**10.3 Main Steam Supply System**

The information in this subsection of the reference ABWR DCD, including all subsections, tables, and figures, is incorporated by reference with the following departures and supplements.

STP DEP 10.2-1 (Table 10.3-1, Figures 10.3-1 and 10.3-2)

Figure 10.3-2 Main Steam Turbine System

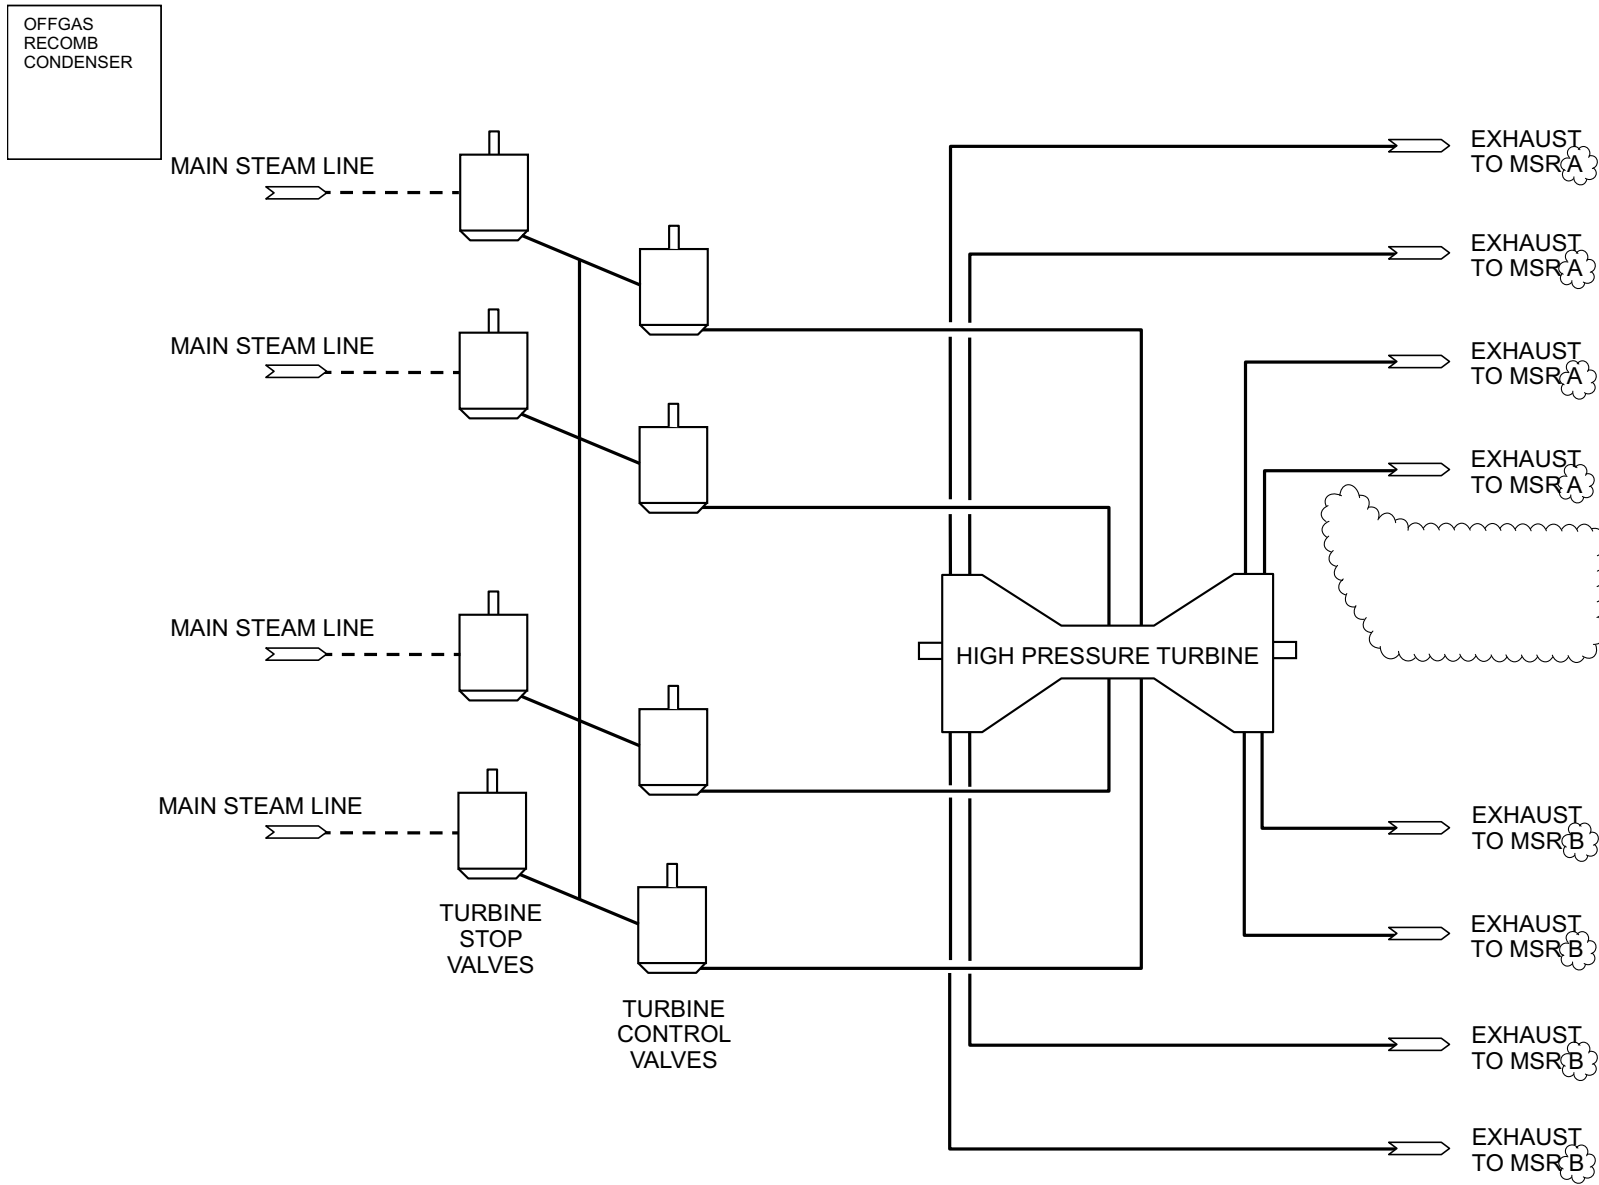
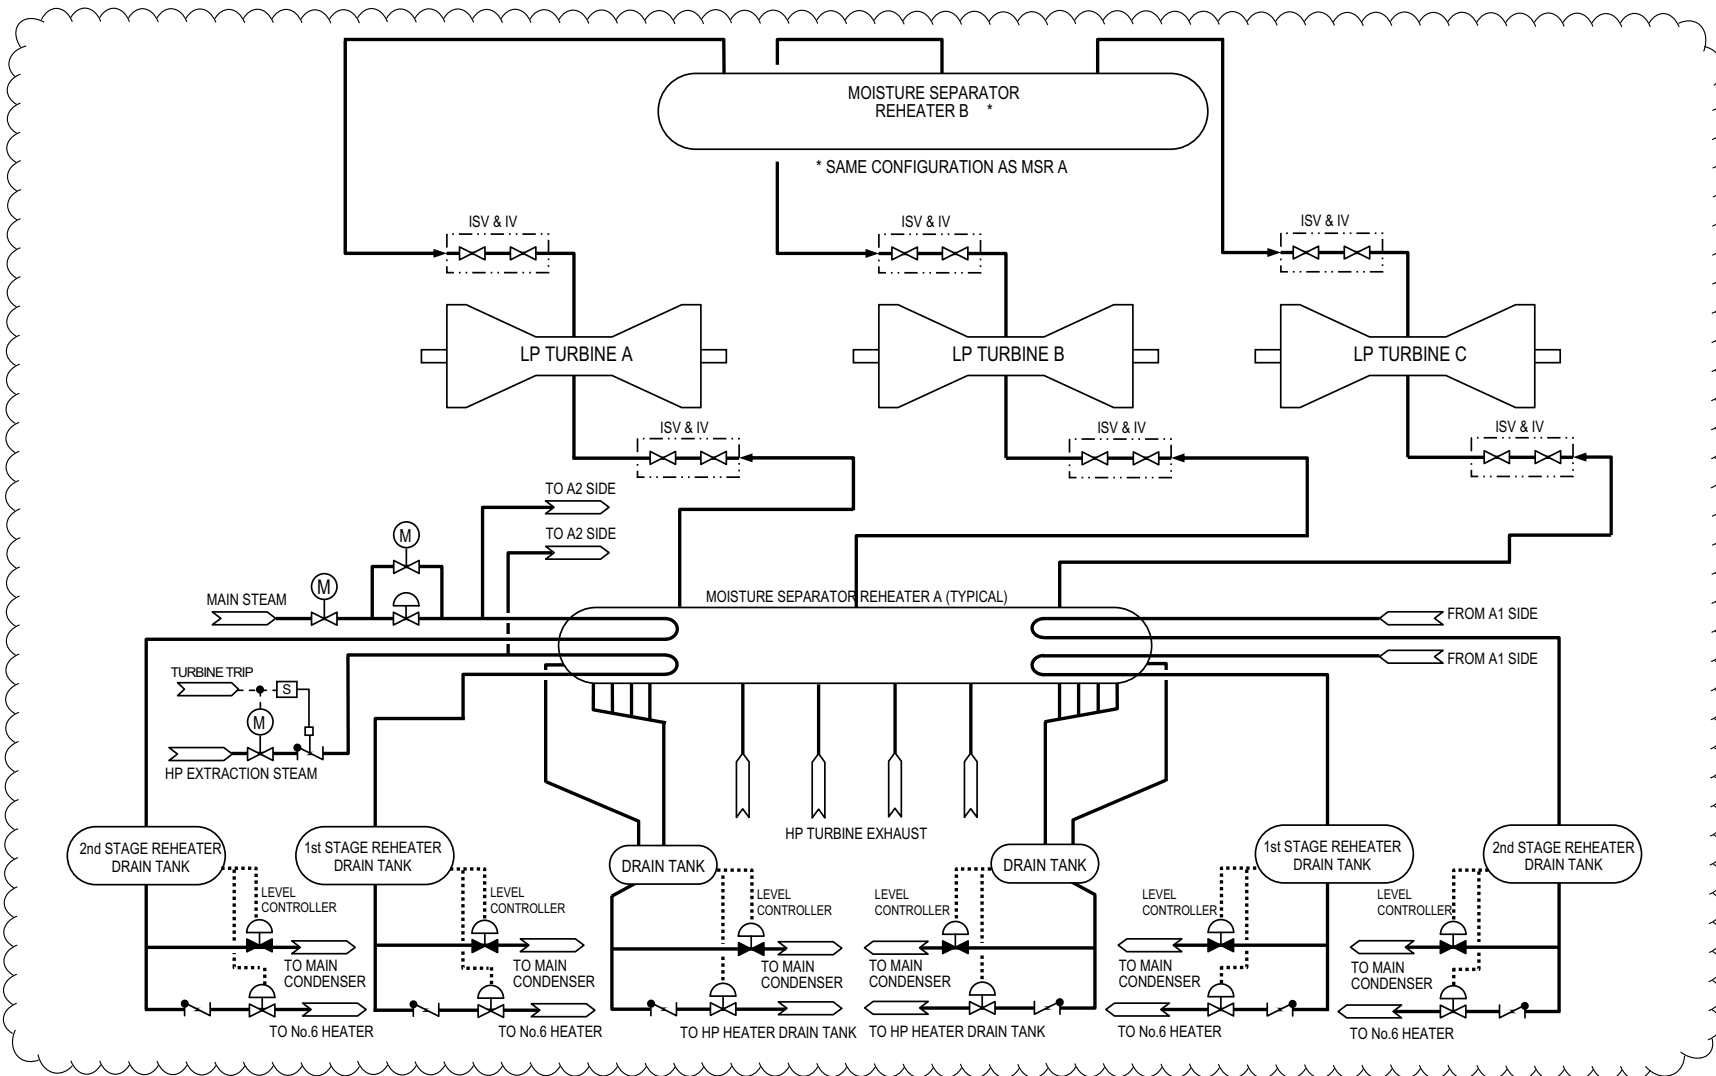
STP DEP 10.4-3 (Figure 10.3-2)
